HISTORIC AND DESIGN REVIEW COMMISSION

February 21, 2024

HDRC CASE NO: 2024-039
ADDRESS: 511 MISSION ST
LEGAL DESCRIPTION: NCB 2879 BLK 4 LOT 5
ZONING: RM-4,H
CITY COUNCIL DIST.: 1
DISTRICT: King William Historic District
APPLICANT: PHILLIP DECKARD
OWNER: PHILLIP DECKARD
TYPE OF WORK: Balcony modification, column replacement
APPLICATION RECEIVED: February 09, 2024
60-DAY REVIEW: March 2, 2024
CASE MANAGER: Claudia Espinosa

**PHILLIP "WORAN" DECKARD
511 MISSION STREET, SAN ANTONIO, TX 78210
BALCONY REPAIR AND REMODEL**

WALL SECTION

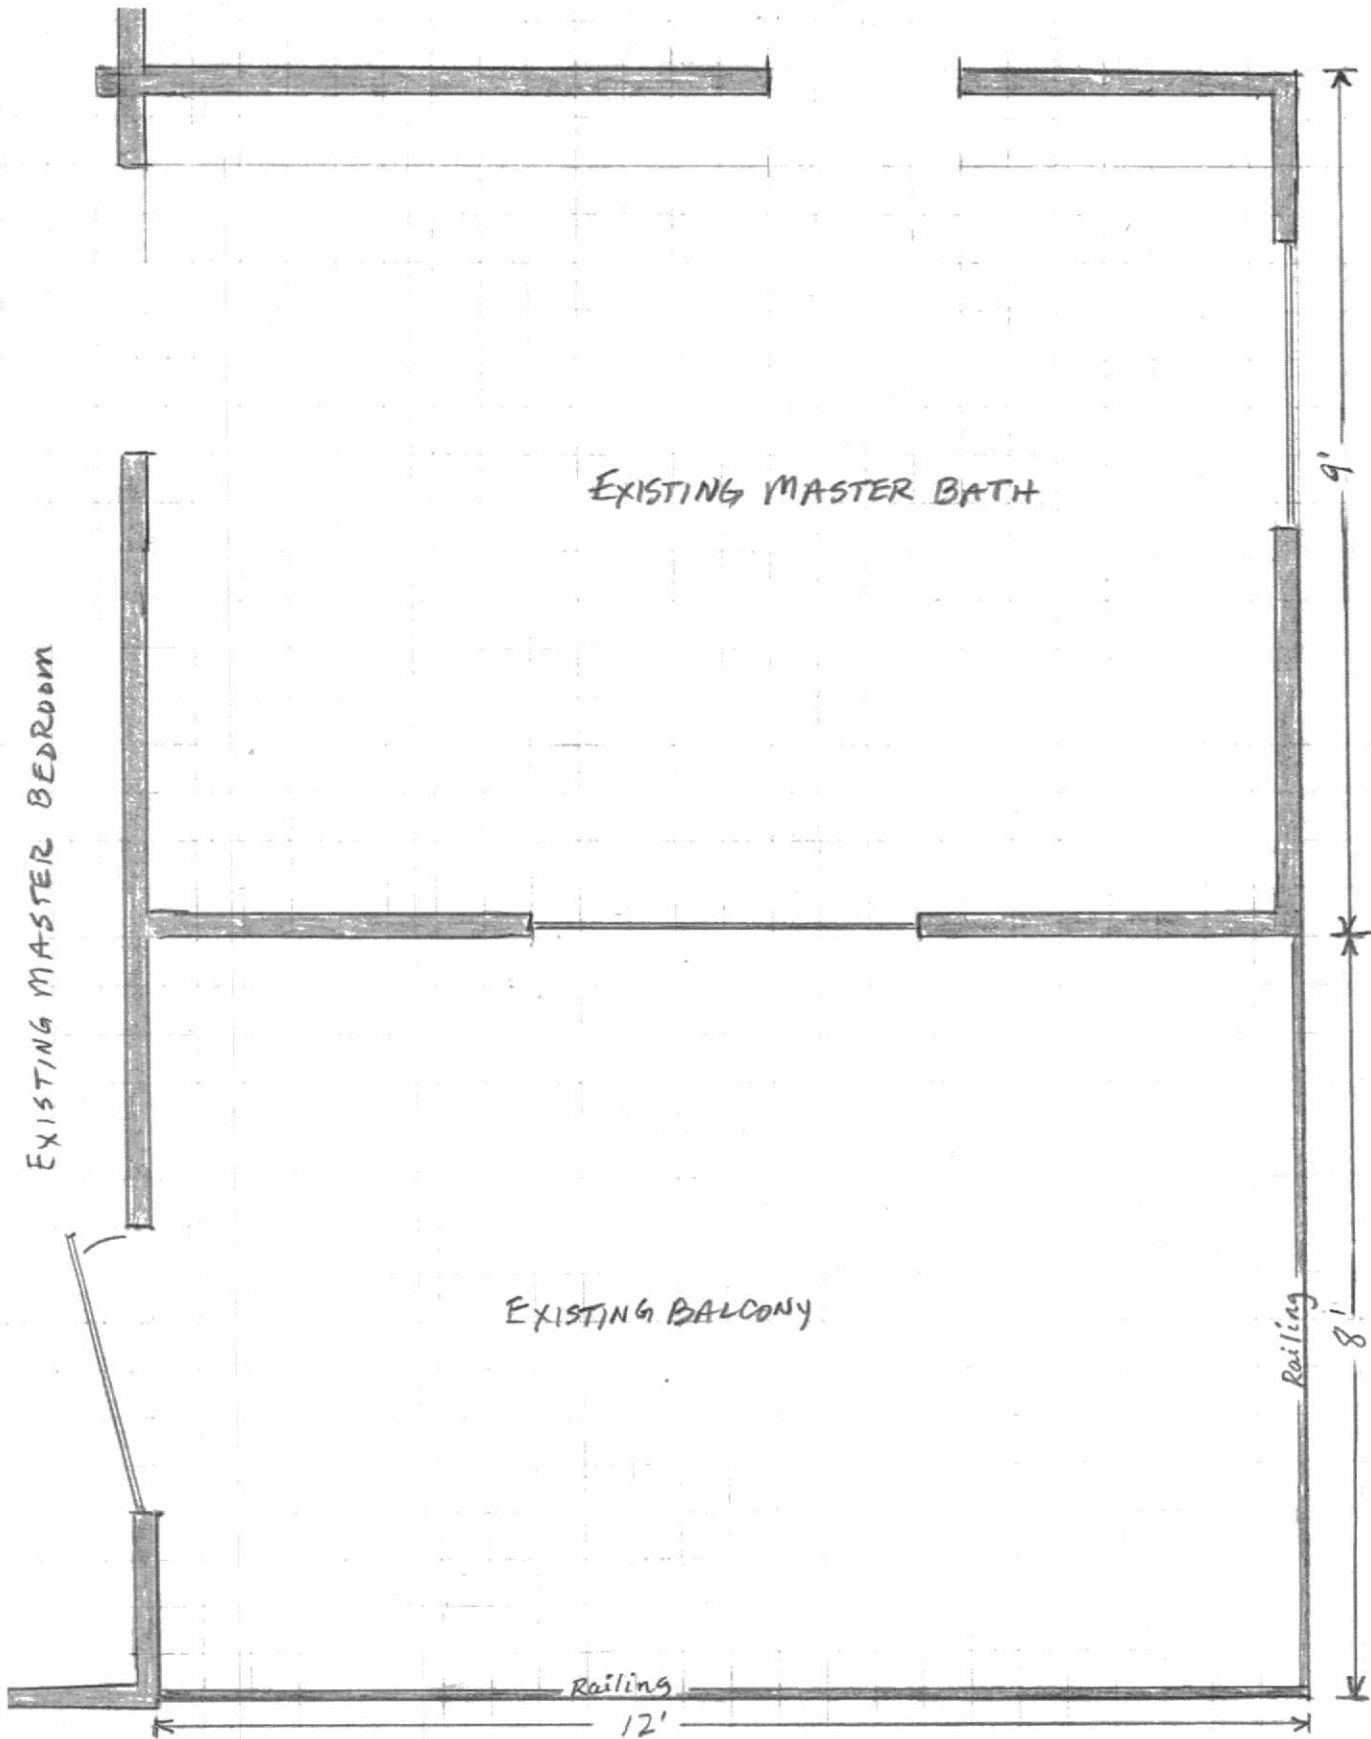
Item 1, staff does not recommend approval of enclosing the second-story front porch based on finding a and b. Staff recommends that the applicant submits to-scale measured elevation drawings, and floor plans and roof plans as needed, to demonstrate the proposed scope to staff for review prior to returning to HDRC.

CONVERTED FROM BEDROOM
TO BALCONY IN 1983.

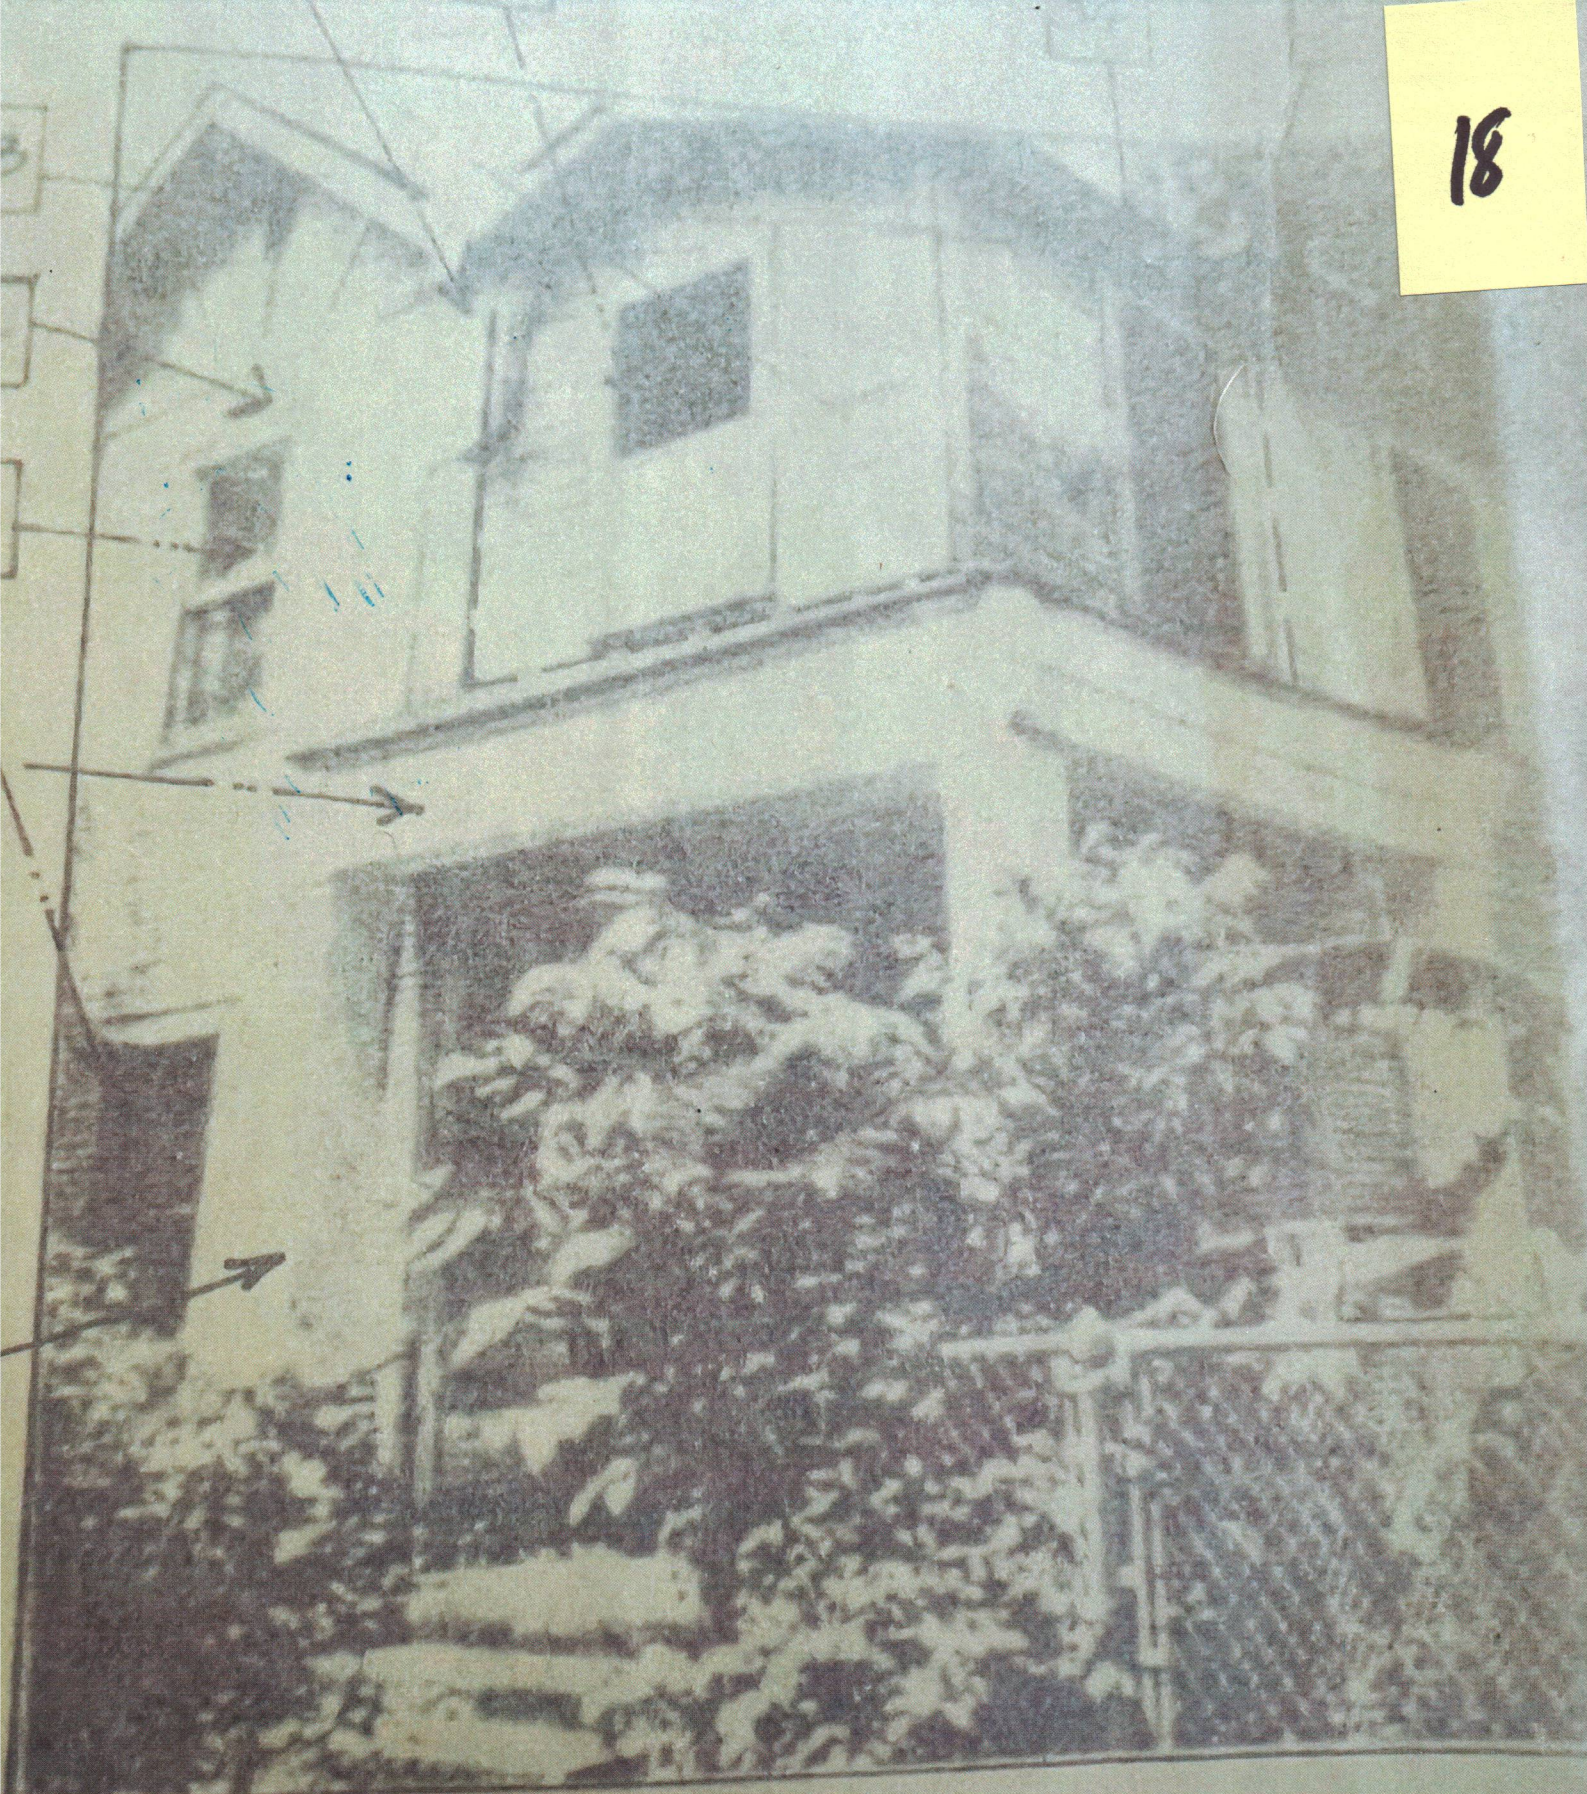
- After repair we want to convert the balcony back to living space. Picture 14 illustrates what we want to do with the space and how the exterior would look.
- We would keep the general look and siding matching the remainder of the house.
- Picture 15 shows the 2nd floor demolition plan as part of the plans dated September 1983. I have highlighted in yellow the portion of the bedroom converted to the balcony in 1983.
- Pictures 16, 17 and 18 show how the home looked before the balcony conversion. It is clearly seen that bedroom number 2 extended over the front porch.
- Prior to 1983, the home also had square pillars and we plan to convert the porch pillars to square pillars.
- We will keep the shed roof that exists over the balcony and the architectural details of the porch façade.
